DSP motherboard, (sheet 5) The RS232 switch Farnell part number has been corrected. Please verify all numbers given in these documents though by checking Data sheets etc.

THESE ARE THE SCHEMATICS FOR COMBO STAR Vers "BB"

COMBO STAR

Sheet:	SCHEMATICS BY VK3PE & C.S.	
5	TITLE:- H:COMBO-SCHEMATIC-PROJECT-121109/COMBO-DSP_MBD.sch	
of	FOR PANEL	
16	"VK3PE"	Vers

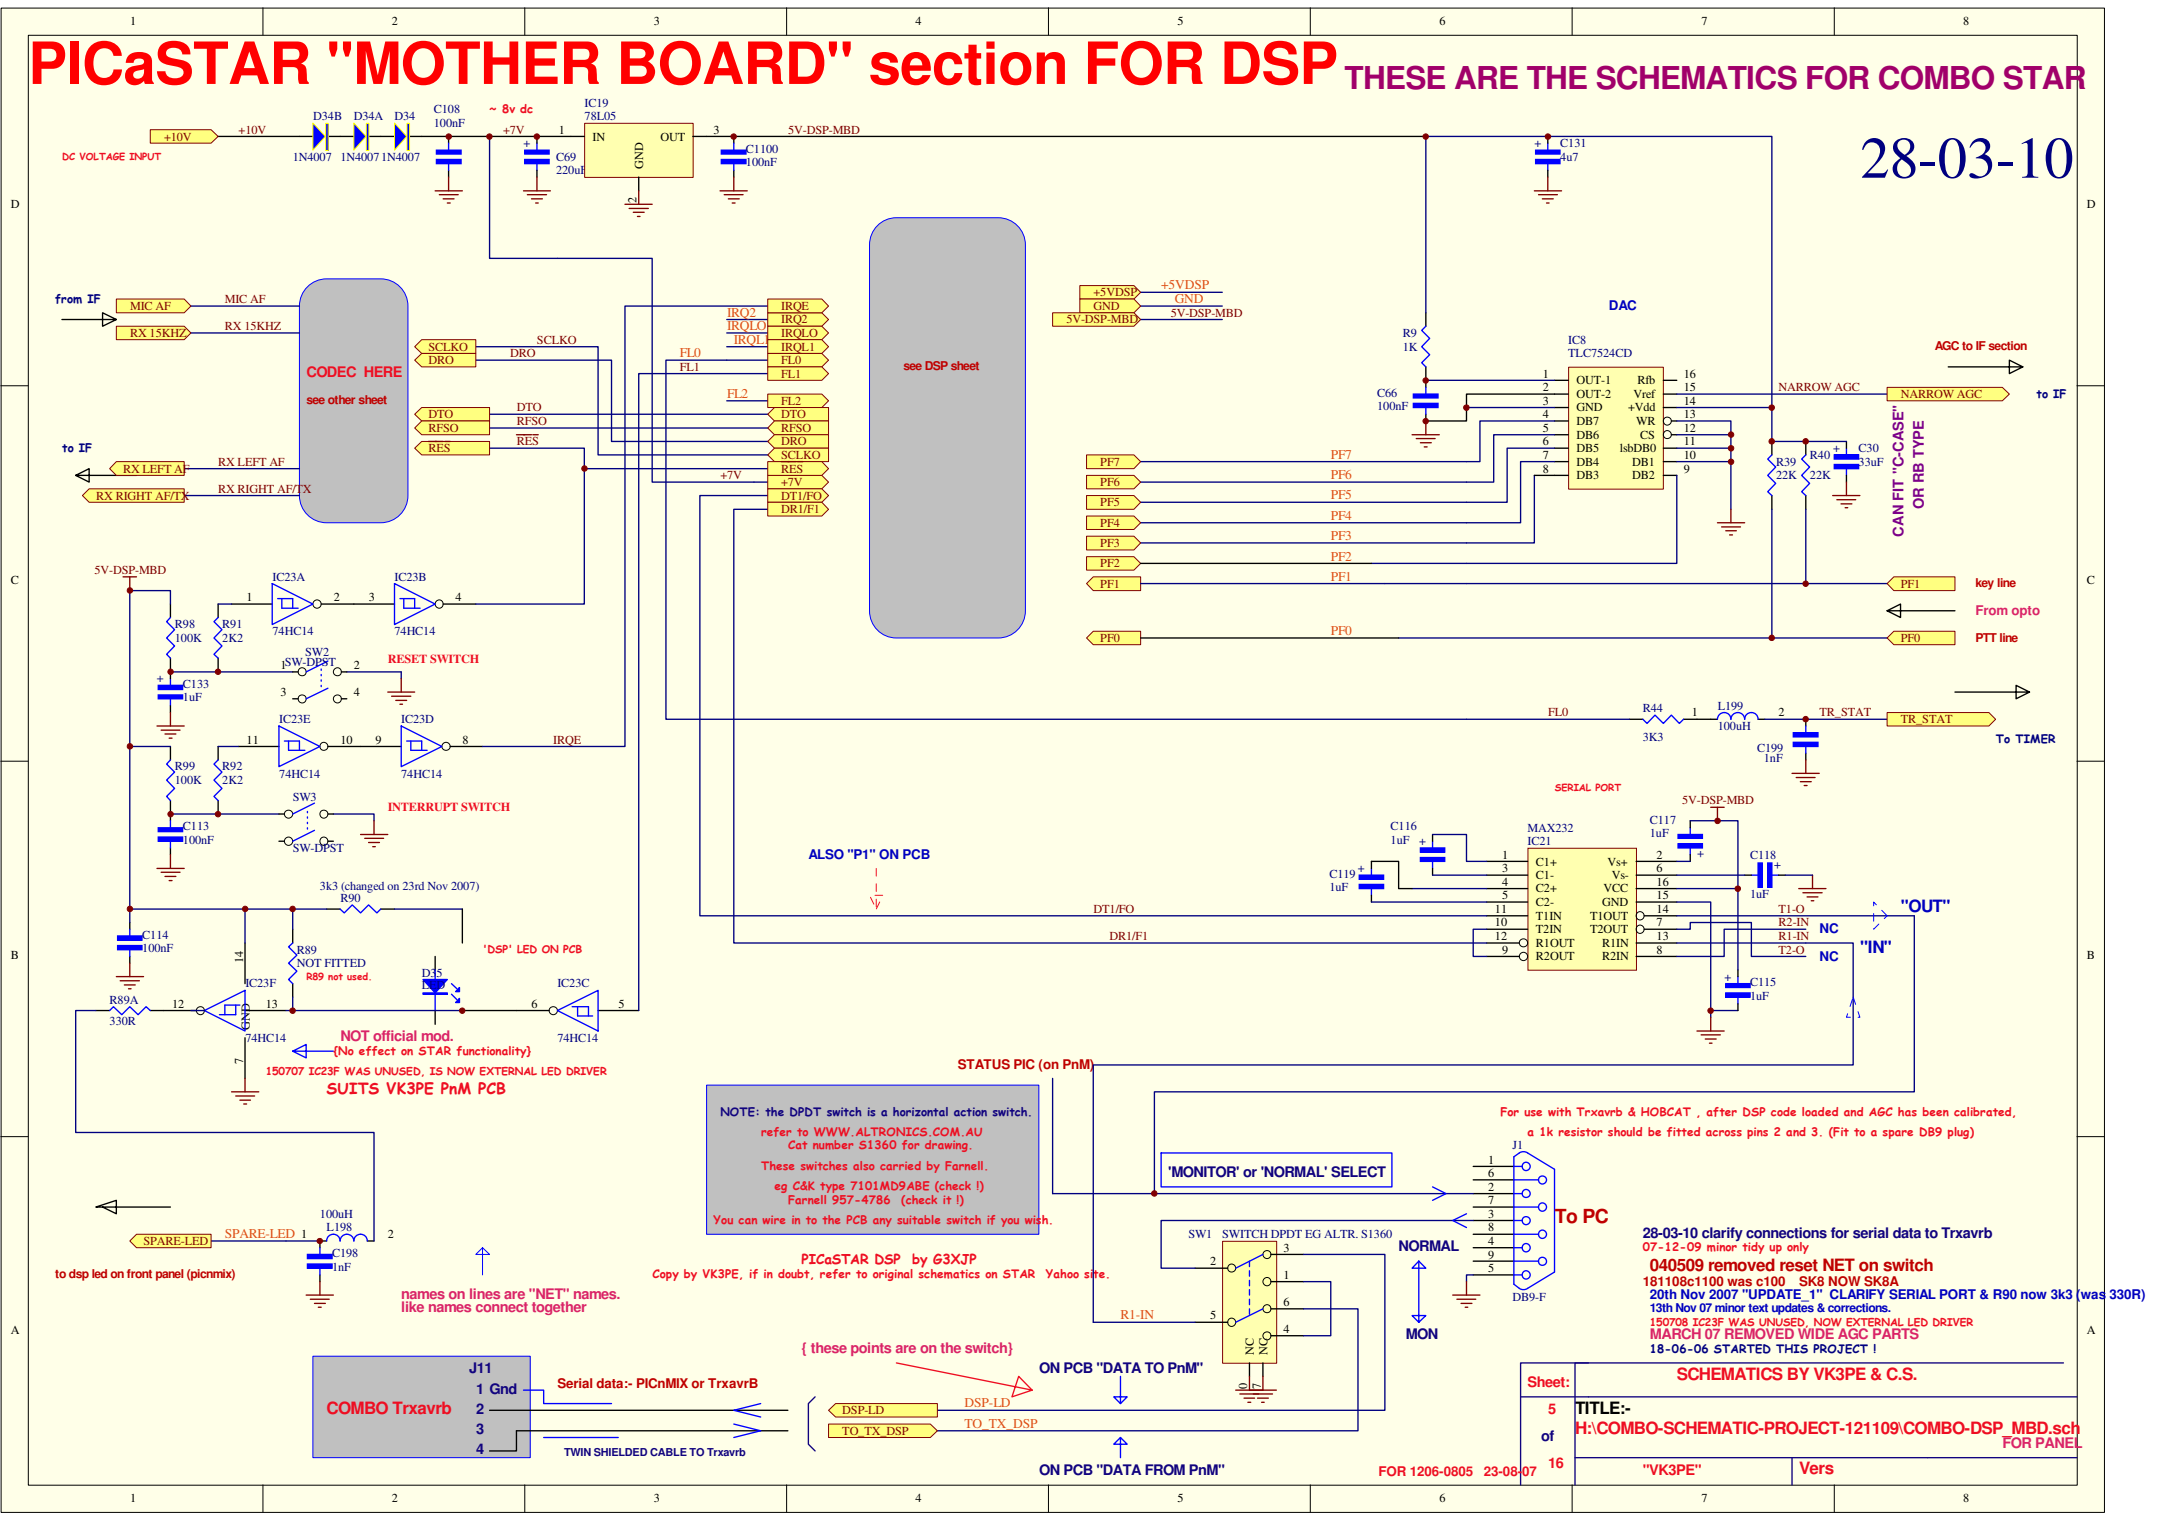
The DSP motherboard area (sheet 5) has been updated to clarify the connections from the Serial Data switch routing to the Trxavrb PCB (or PICnMIX if used) See bottom area of the sheet.

28-03-10 clarify connections for serial data to TrxavrB
07-12-09 minor tidy up only
040509 removed reset NET on switch
181108c1100 was c100 SK8 NOW SK8A
20th Nov 2007 "UPDATE_1" CLARIFY SERIAL PORT & R90 now 3k3 (was 330R)
13th Nov 07 minor text updates & corrections.
150708 IC23F WAS UNUSED, NOW EXTERNAL LED DRIVER
MARCH 07 REMOVED WIDE AGC PARTS
18-06-06 STARTED THIS PROJECT!

Sheet: **14-01-09** PICASTAR SCHEMATICS BY VK3PE
BASED ON ORIGINALS (C) BY G3XJP

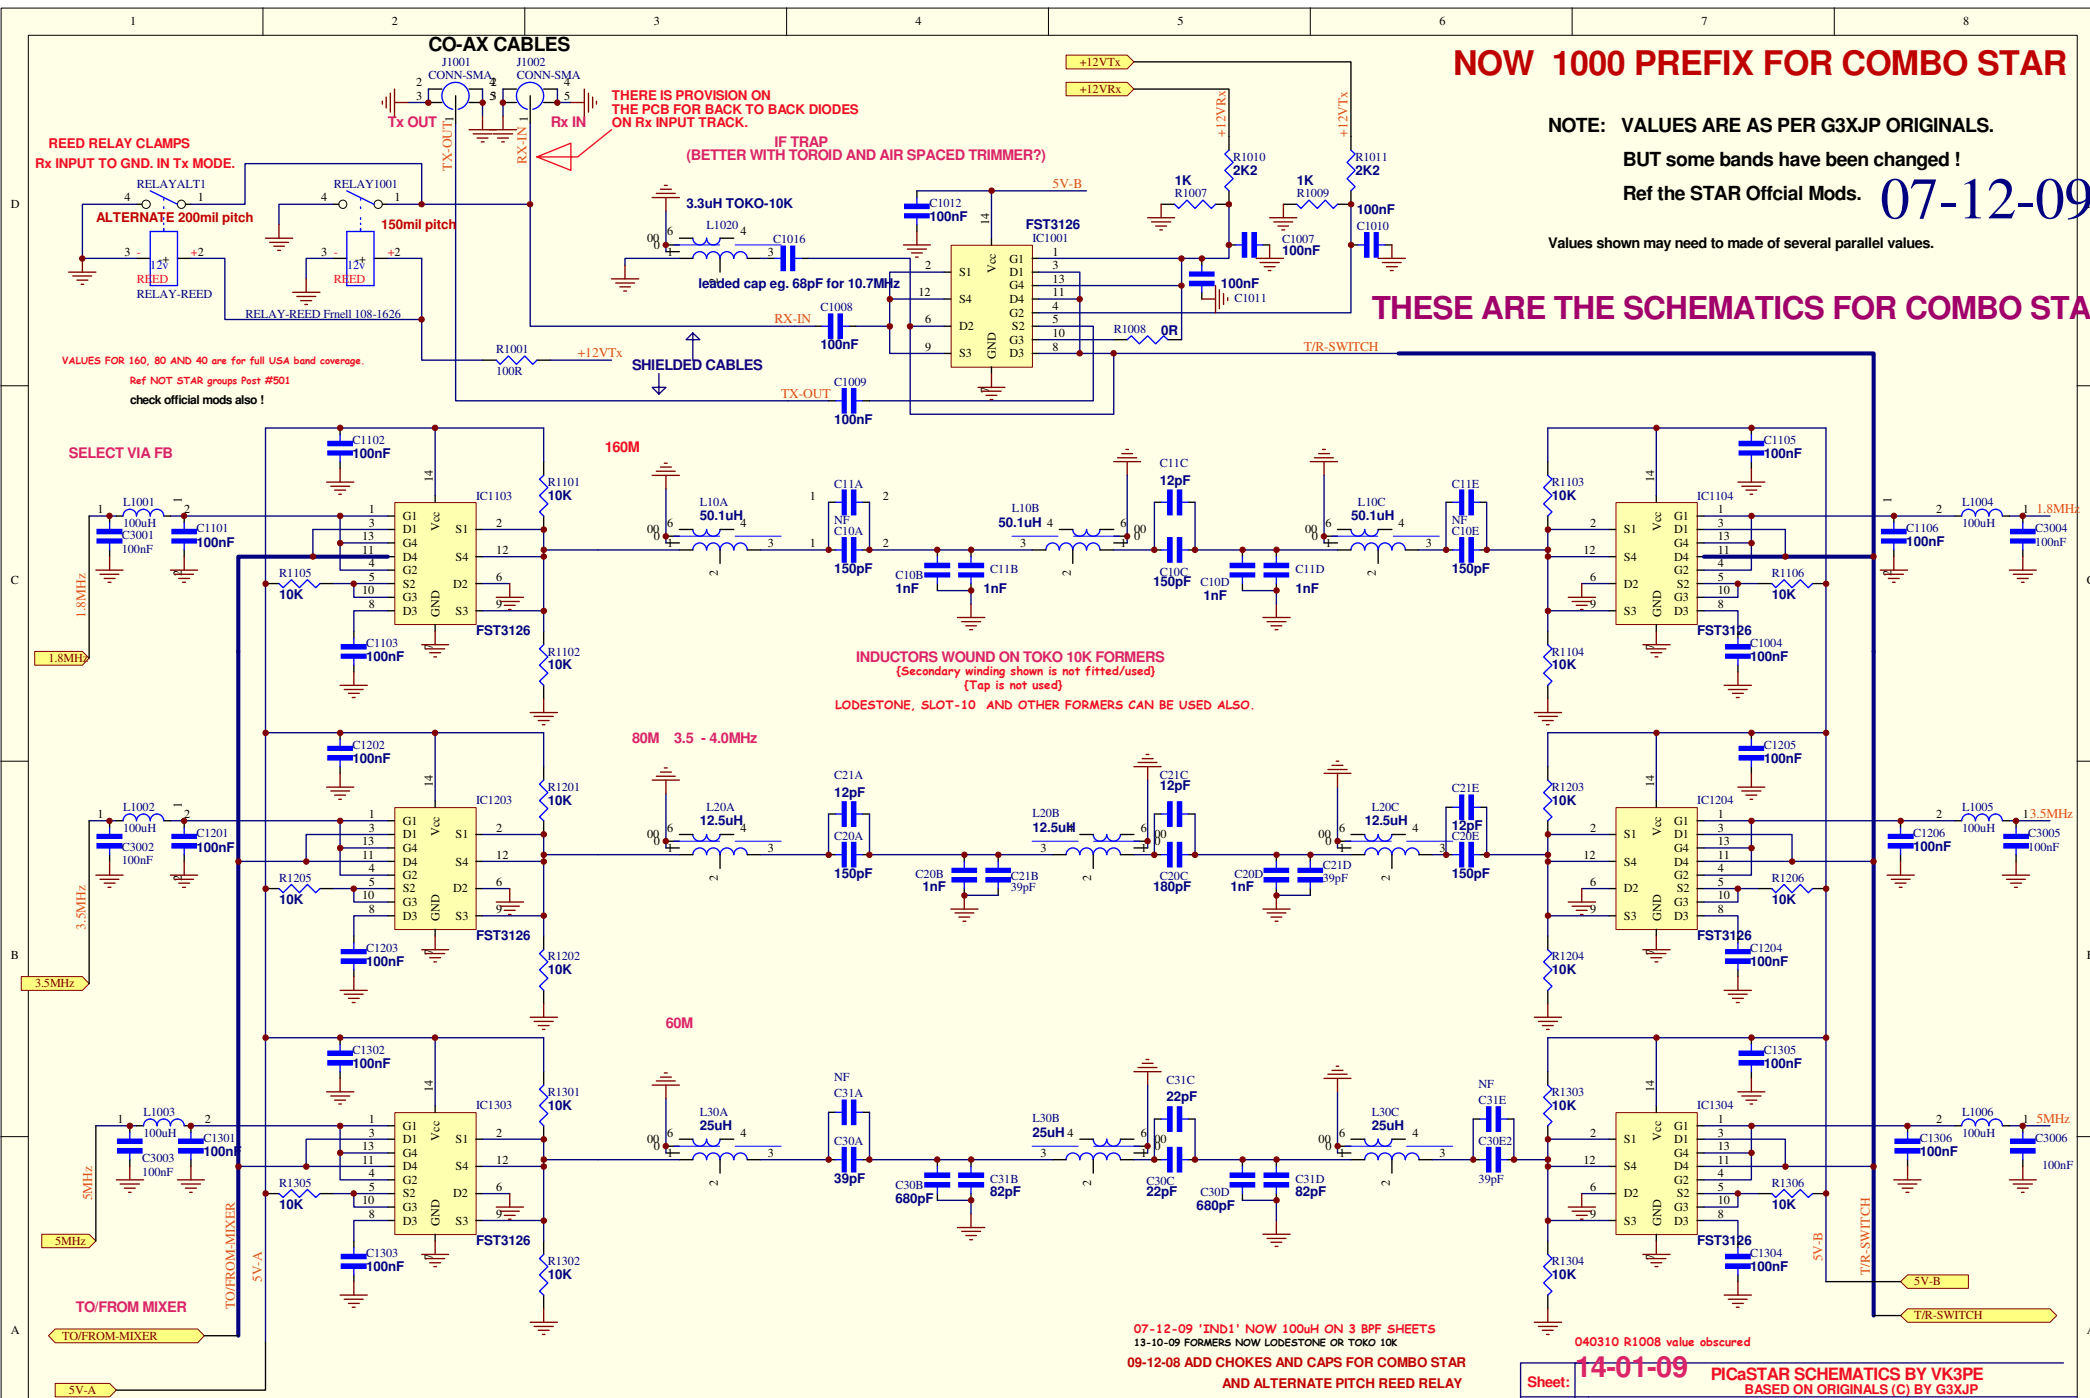
07-12-09 'IND1' NOW 100uH ON 3 BPF SHEETS

040310 R1008 value obscured

Sheet:	8
of	16
TITLE:-	COMBO SCHEMATIC FOR PICaSTAR MAGIC ROUNDABOUT
File Name:	COMBO-MR.sch
Author:	VK3PE
Vers	Ver A panel

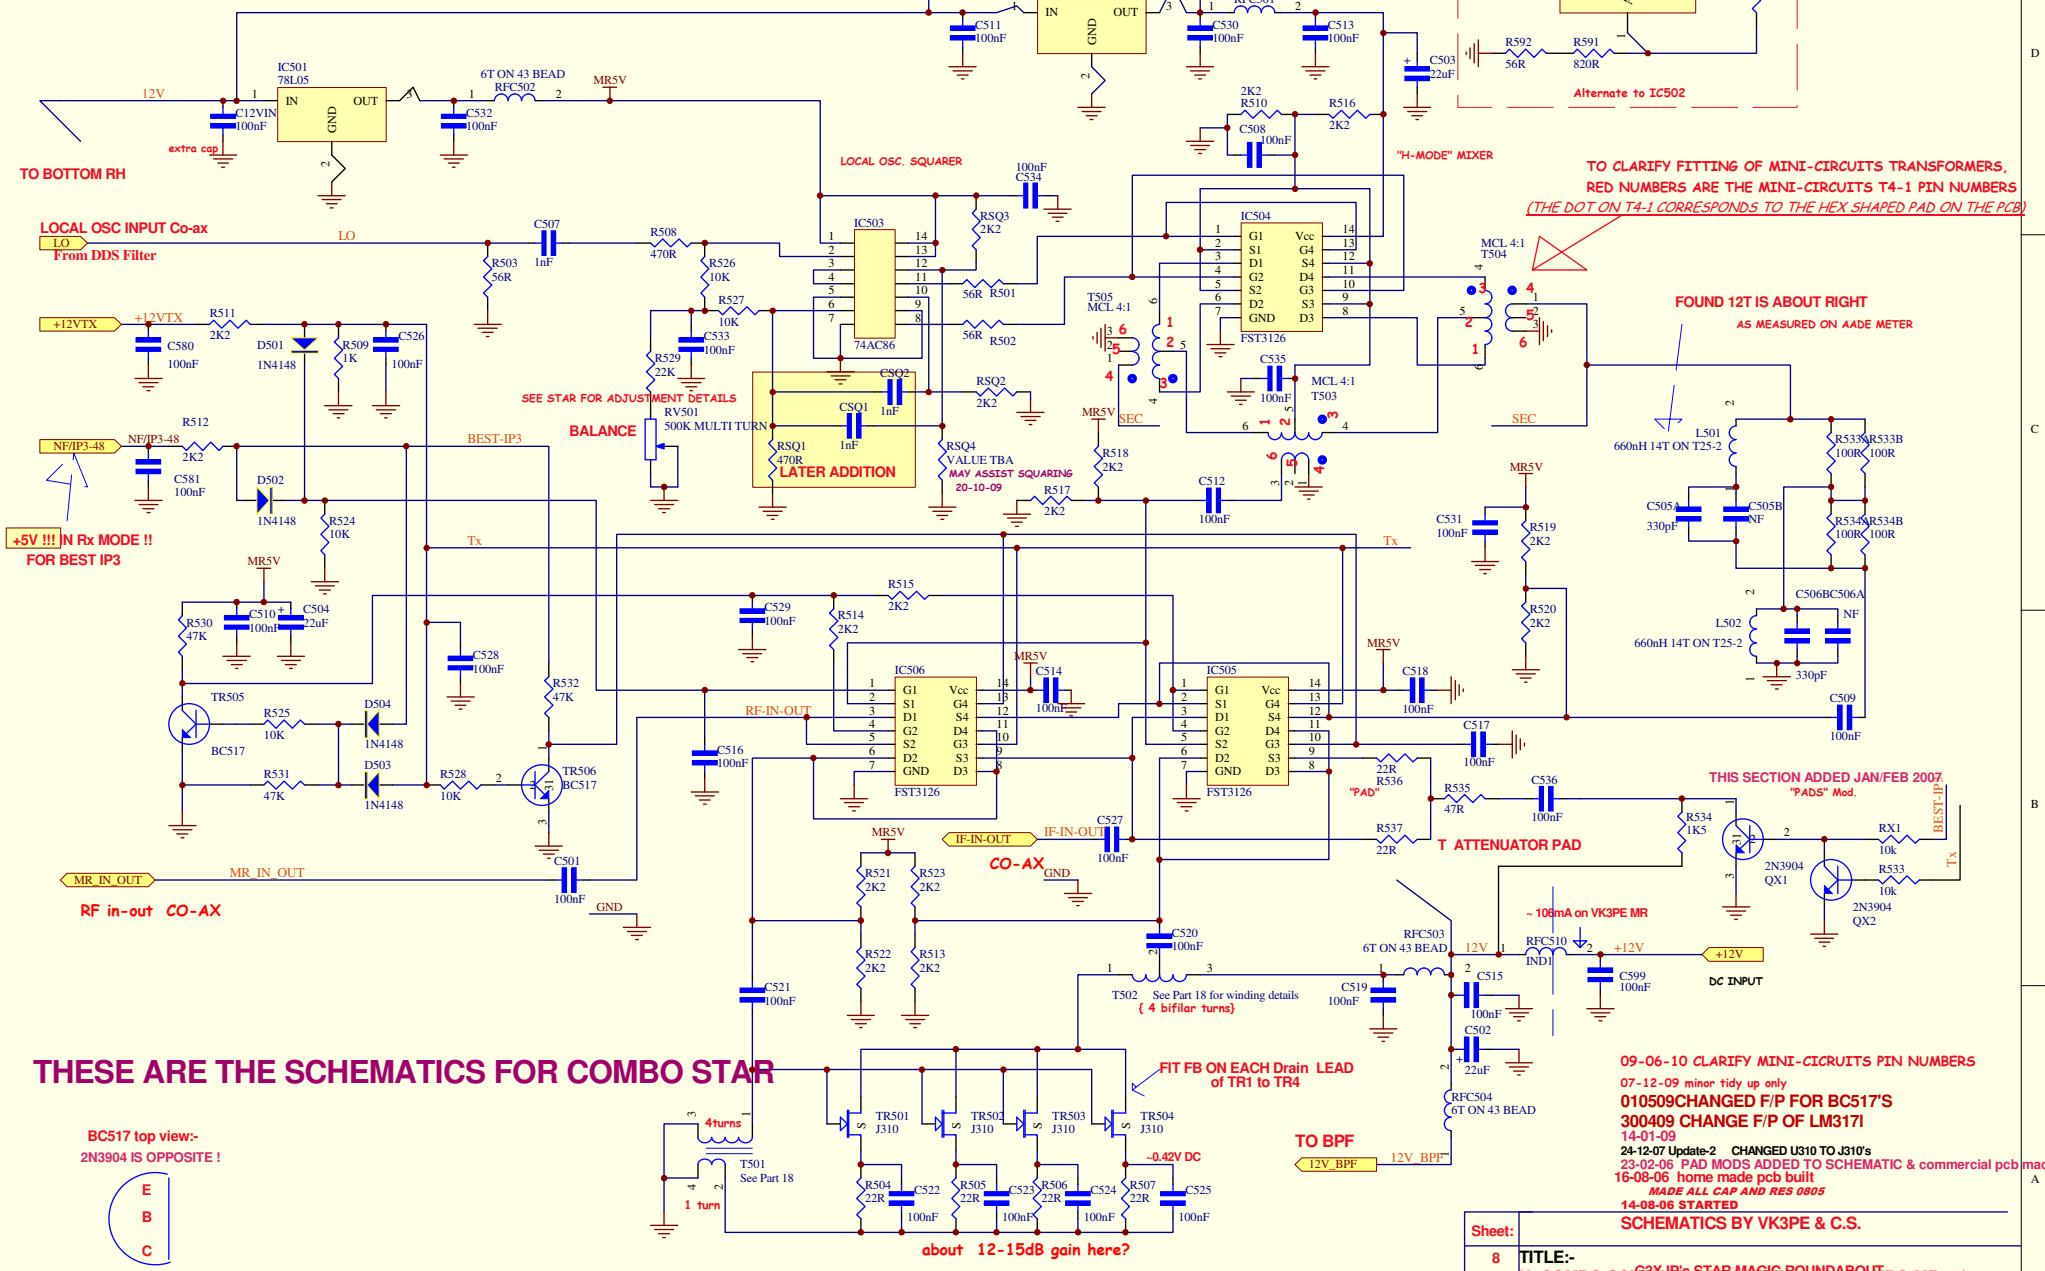
Clarified pinout of the Mini-Circuits T4-1 transformers in Magic Roundabout, sheet 8. (added pin numbers in red, of the T4-1, to the transformers. Also, a note in top right corner.)

09-06-10 CLARIFY MINI-CIRCUITS PIN NUMBERS
 07-12-09 minor tidy up only
 010509 CHANGED F/P FOR BC517'S
 300409 CHANGE F/P OF LM3171
 14-01-09
 24-12-07 Update-2 CHANGED U310 TO J310's
 23-02-06 PAD MODS ADDED TO SCHEMATIC & commercial pcb made
 16-08-06 home made pcb built
 MADE ALL CAP AND RES 0805
 14-08-06 STARTED
 SCHEMATICS BY VK3PE & C.S.
